**TOWN OF NEWBURGH
PLANNING BOARD
REVIEW COMMENTS**

PROJECT: BRITAIN PLAZA
PROJECT NO.: 13-13
PROJECT LOCATION: SECTION 97, BLOCK 3, LOT 1
PROJECT REPRESENTATIVE: LANC & TULLY, PC
REVIEW DATE: 30 JULY 2014
MEETING DATE: 7 AUGUST 2014

RE: Britain Plaza – Commercial Site Plan - ARB
Tax Parcel: 97 – 3 – 1
Planning Board No.: 2013-13

Enclosed and as requested please find twelve (12) complete plan sets a Site Plan entitled "Commercial Site Plan – Britain Plaza", Sheets 1-6 of 6, dated June 30, 2014 and last revised July 21, 2014. The site plan set has been revised to address comments received from the Planning Board Members and the consultants. To assist in your review, we have annotated the comments and our responses below:

LANDSCAPING / SIGNAGE
PLAN AND DETAILS

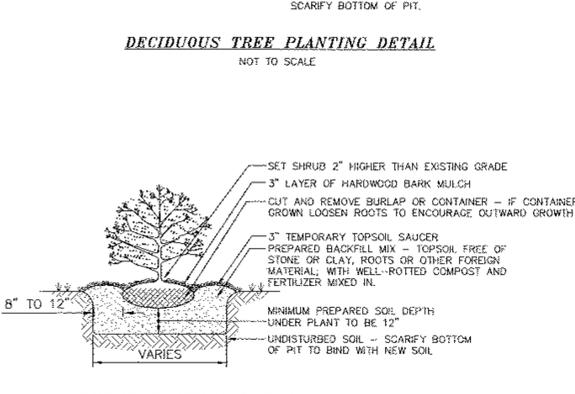
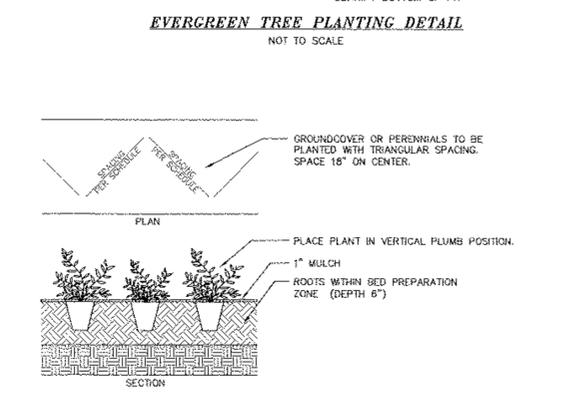
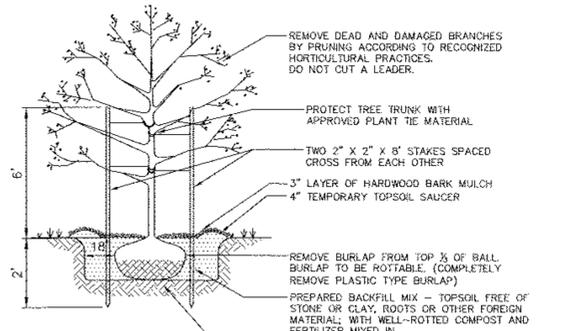
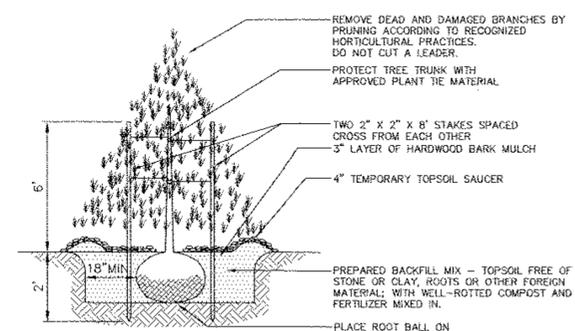
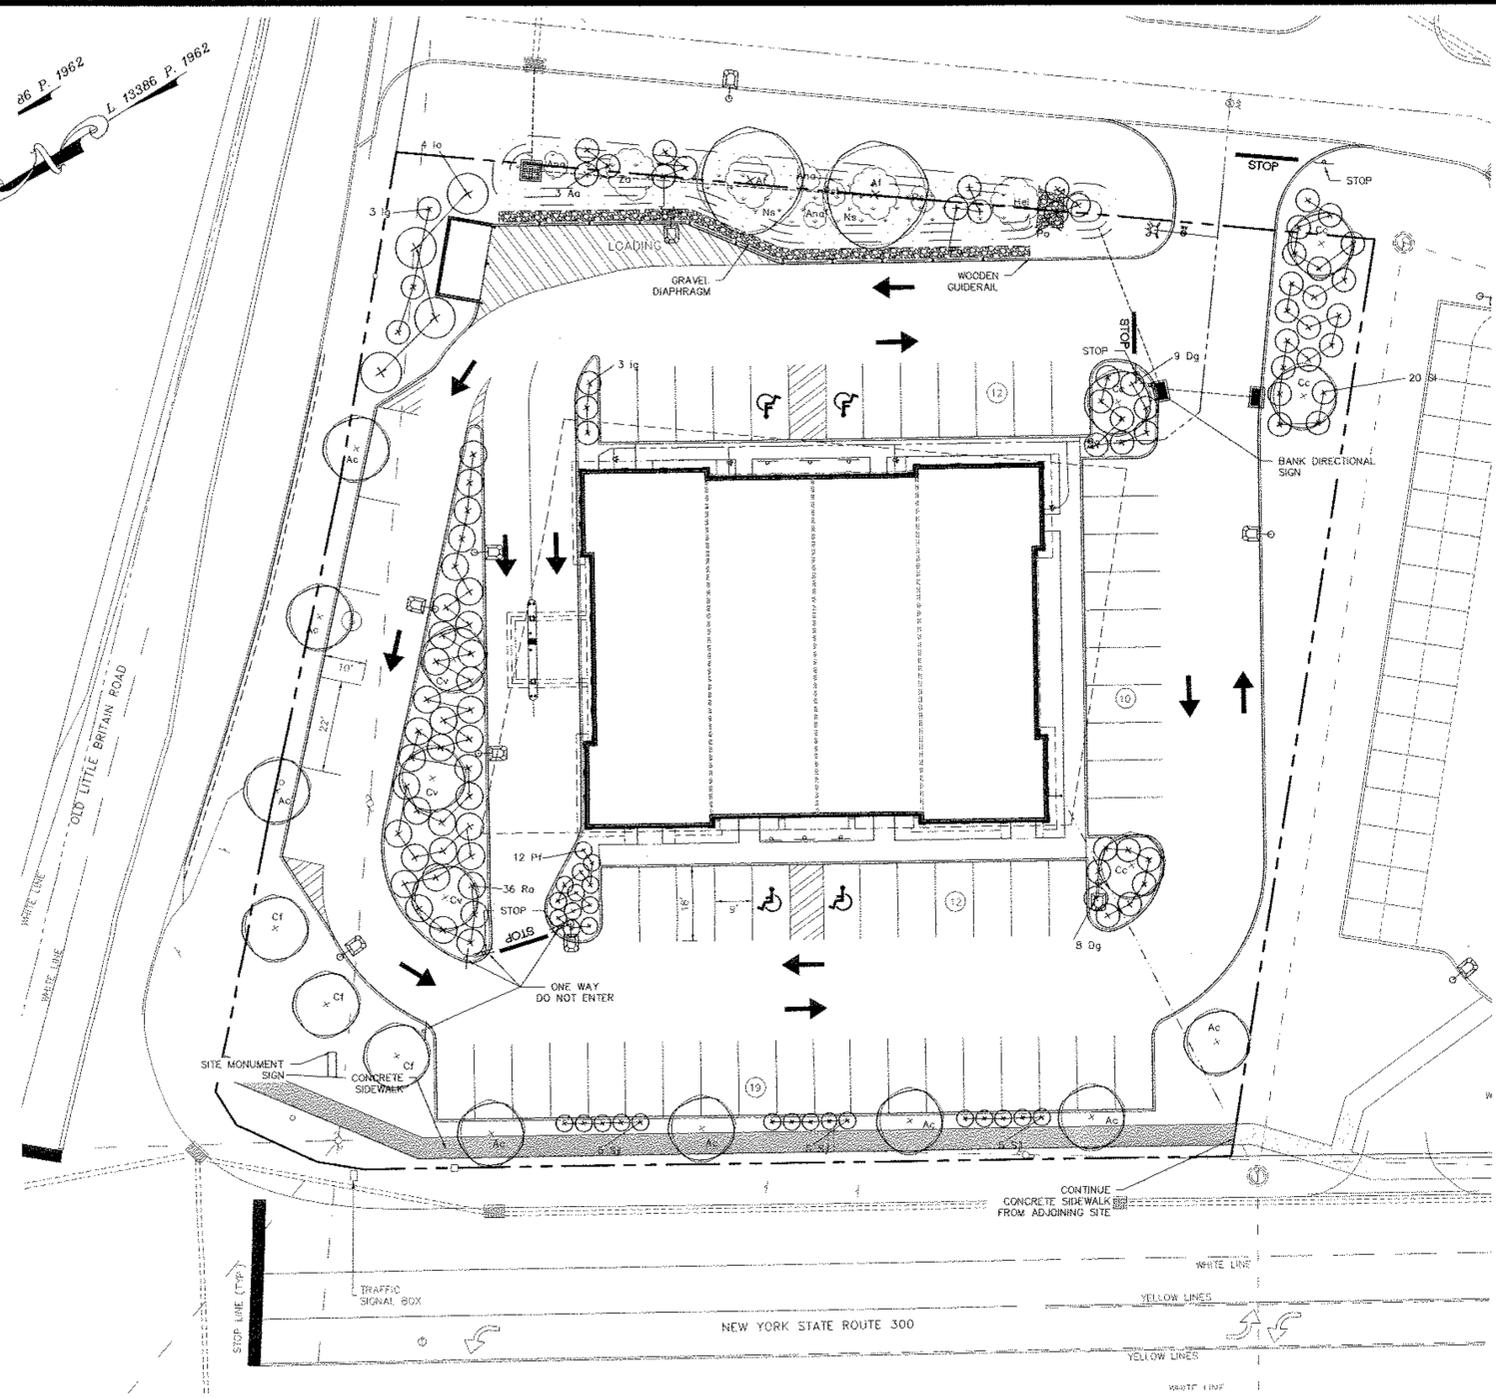
1. Approval of the project cannot occur until Town Board action on allowing Banks within the IB District.
2. Planning Board should review landscaping proposed at dumpster enclosure as discussed at previous meeting.

6. The Planning Board may wish to review the detail of the proposed monument sign located at the northern property corner at NYS Route 300 and Old Little Britain Road. No detail of the sign size, etc. have been provided.

The Planning Board would like the Landscaping augmented in the area of the dumpster enclosure (front yard setback) prior to approving the dumpster location.

The landscaping around the dumpster enclosure has been augmented to include three (3) Inkberry shrubs in addition to the three (3) American Holly shrubs. Both plant types are evergreen. The Inkberry Holly will grow to 3 to 4 feet tall and spread. The American Holly will grow to 15 to 30 feet tall, but on this site should be maintained to a 10 to 12 foot height. The combination of the two evergreens with the varying heights should provide an adequate screening of the dumpster enclosure. Additionally, the dumpster enclosure will be a 6 foot tall, split face block enclosure in an earth tone color as indicated by the detail included on Sheet 6 of 6 of the plan set. If the augmented landscaping is acceptable, we would respectfully request the Planning Board approve the location of the dumpster enclosure.

7. *The location of the proposed signage (monument and directional) is contained on Sheet 2 of 6, Landscaping / Signage Plan and Details.*
8. *The site proposes parking within the front yard setback which is contrary to the design guidelines. The parking spaces have been buffered by proposed landscaping including combination of deciduous trees and shrubs. We note that the surrounding commercial sites along NYS Route 300 and Old Little Britain Road have parking within the front yard setback as well. With the proposed screening and consistency with surrounding commercial sites, we would respectfully request a waiver to provide parking in the front yard setback.*

9. *The Lighting Plan and Details have been included in the plan set as Sheet 3 of 6.*

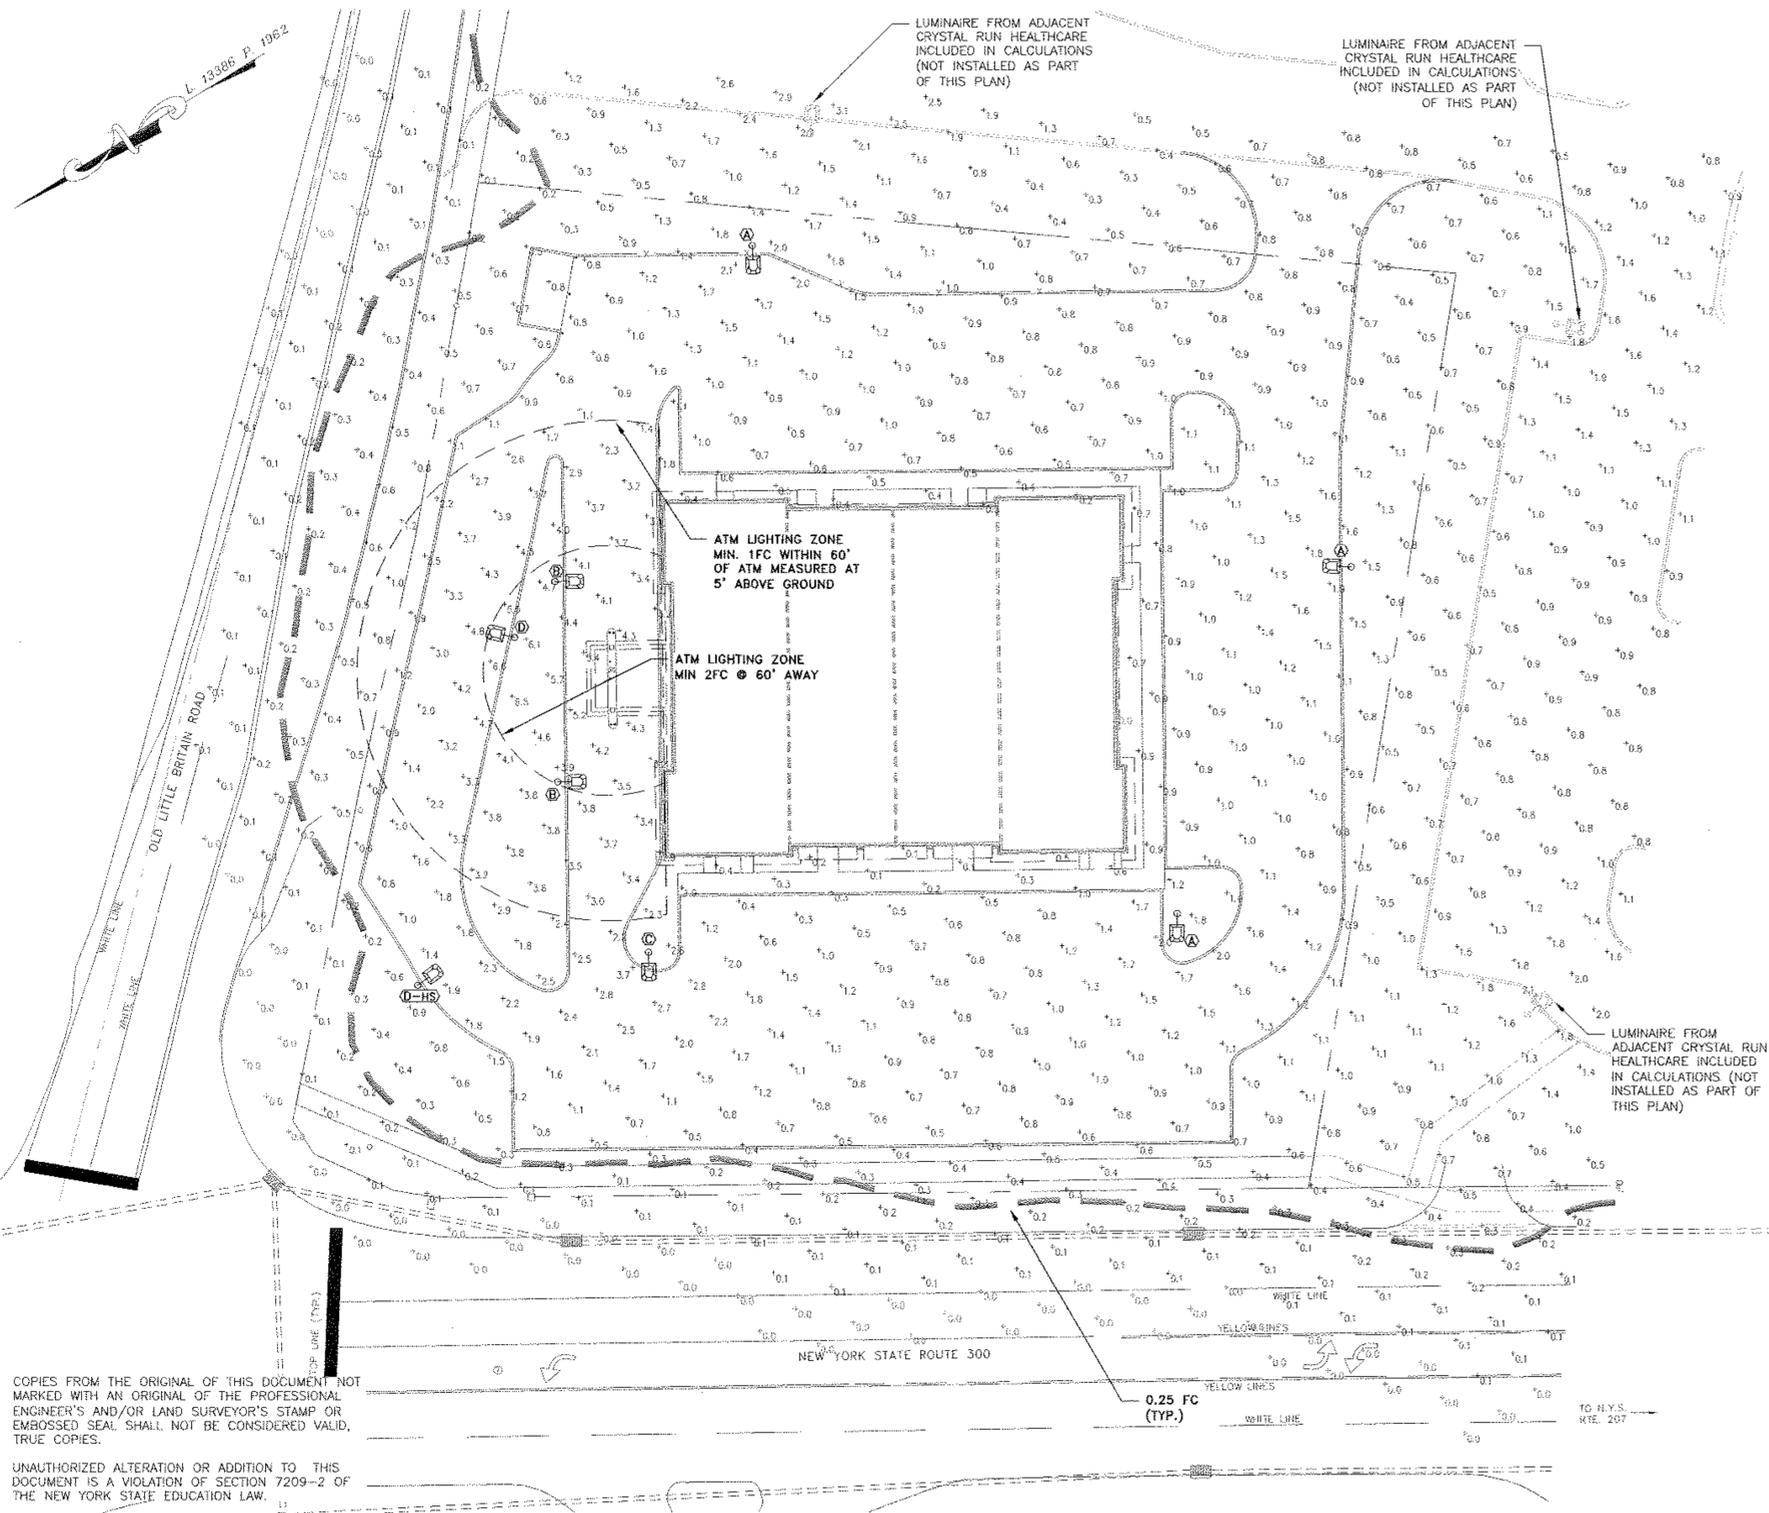
4. Planning Board must consider the waiver for parking within front yard setbacks based on design guidelines.
5. A lighting plan has been submitted with the recent set. Lighting poles are depicted at 28 feet for 5 of the fixtures. The site lighting should be > 16 feet consistent with design guidelines for this size site.
